FROM: Allied Engineering, Inc.
160 Veranda Street
Portland, Maine 04103
Telephone: (207) 221-2260

RE: Addendum No. **Four (4)** to the Bidding Documents for:
NEW Crosby Vehicle Storage Garage, South Portland, ME

This Addendum forms a part of the Contract Documents and modifies the original Bidding Documents dated November 22, 2021. Acknowledge receipt of this Addendum in the space provided on the Proposal Form. Failure to do so may subject Bidder to disqualification.

SHEET NUMBER: C-404

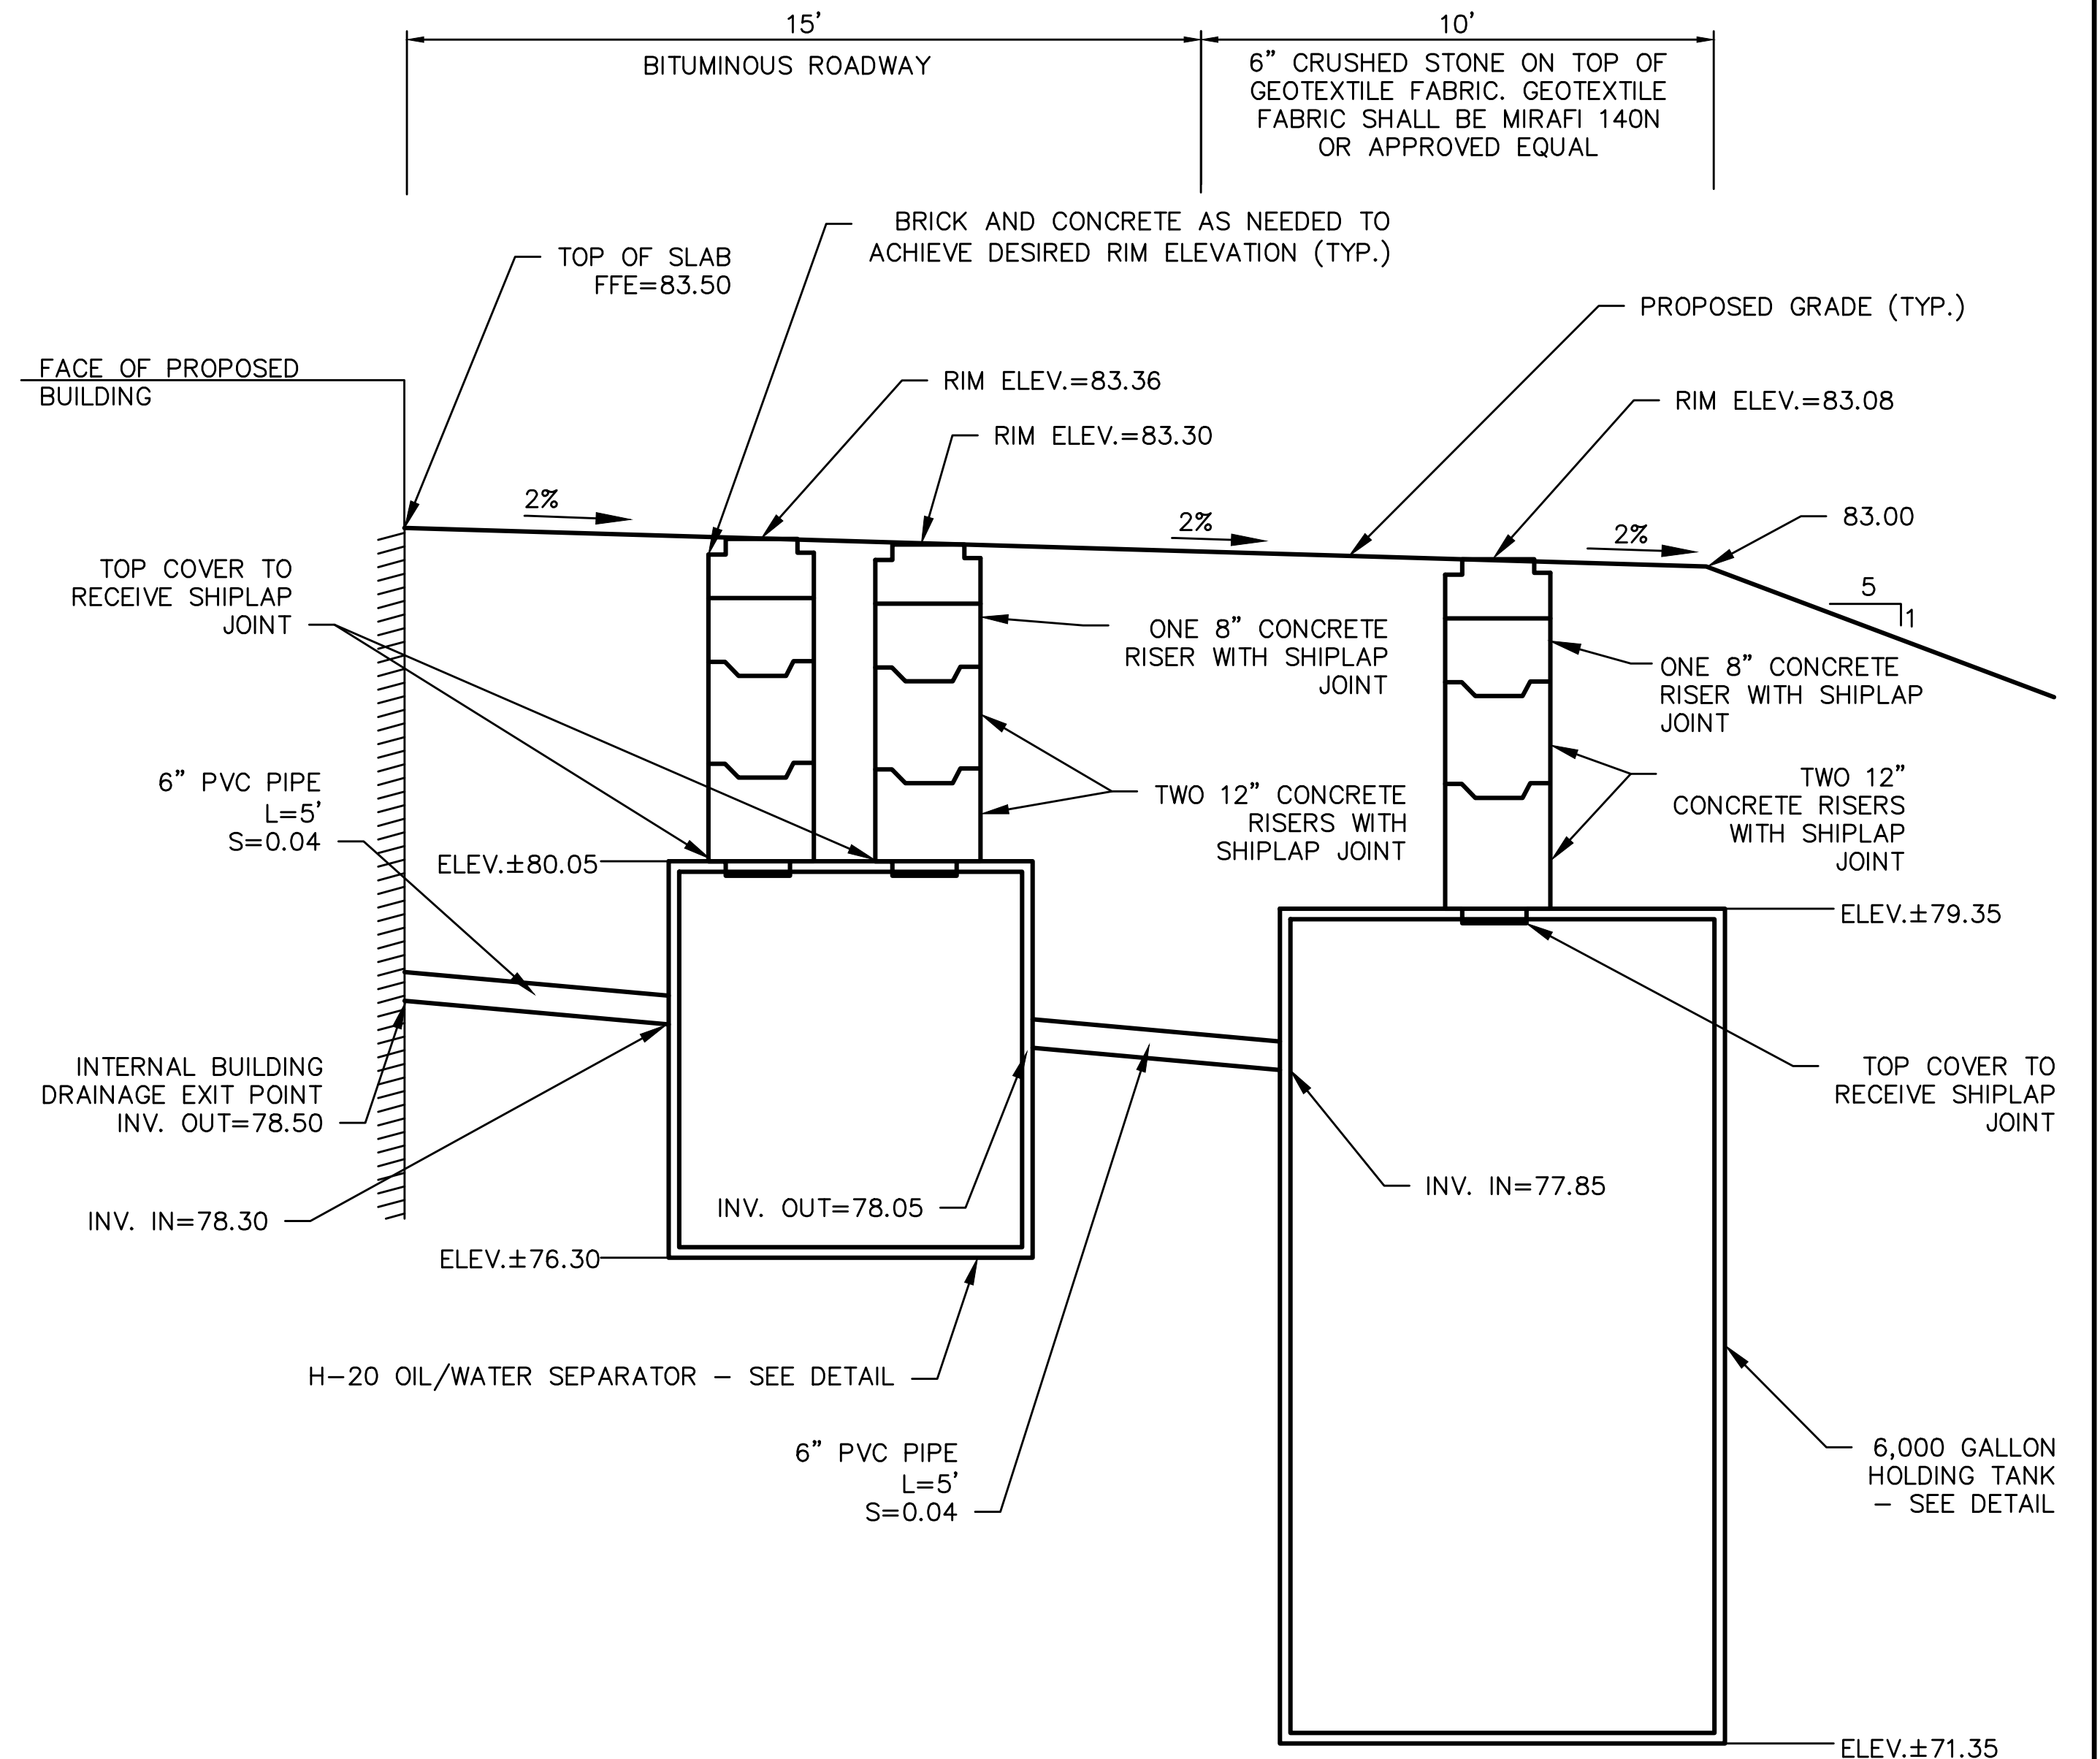
1. **DELETE** Sheet C-404 in its entirety. **ADD** in its place Sheet C-404 in its entirety attached this addendum, revised January 12, 2022.
2. Drawing PP-100 (Sheet 25 of 32): **ADD** Key Note #1 at each of the three unit heaters, GUH-1, GUH-2, and GUH-3 to read as follows:

No.	Revision	By	Date
1	ADDENDUM #4	JSW	1/2022

**SPECIAL GRADING DETAIL
 HOLDING TANK AND OIL/WATER SEPARATOR**
 NOT TO SCALE
